SERVICE LETTER

Service Letter No. L228
April 16, 1990

SUBJECT: Cracking of Cylinder-Head Exhaust Port

MODELS AFFECTED: All field-reconditioned, parallel-valve cylinder heads.

Figure 1. View of Exhaust-Port Area Prone to Cracking

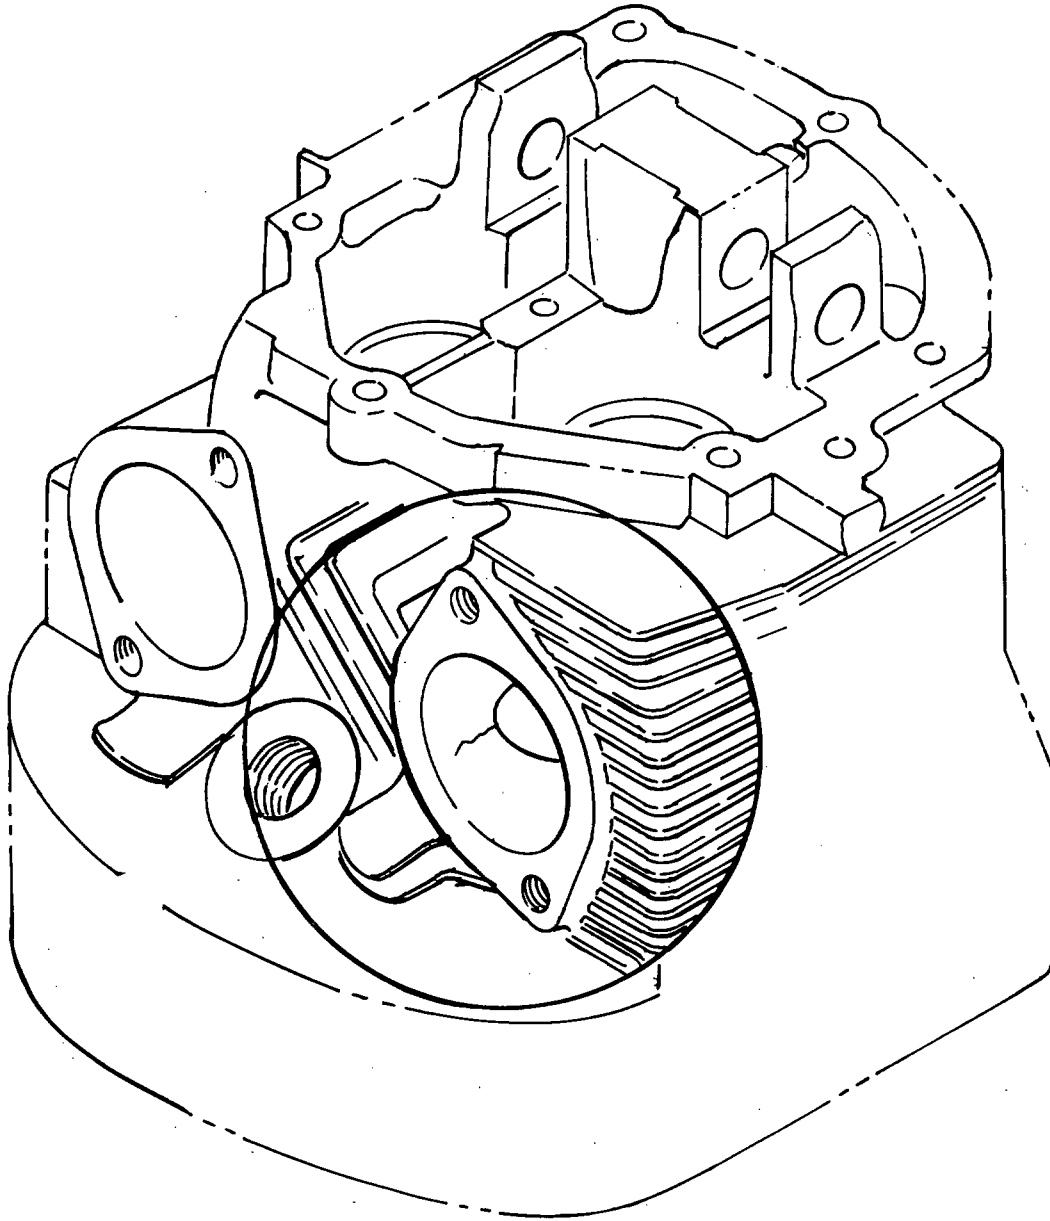
Field inspections have revealed that the cylinder-head exhaust port area on some parallel-valve cylinders reconditioned in the field may be prone to cracking. The cracking is confined to the left side of the exhaust port, next to the spark plug hole (see Figure 1).

Because the cracking may be of such a fine configuration, it can be difficult to detect visually. Therefore, a dye penetrant must be used for inspection purposes. After the dye penetrant has been applied to the left side of the exhaust port, the root areas of the fins next to the spark plug hole can then be inspected for dye seepage.

Textron Lycoming advises replacement of the cylinder-head/barrel assembly, if cracking is evident.
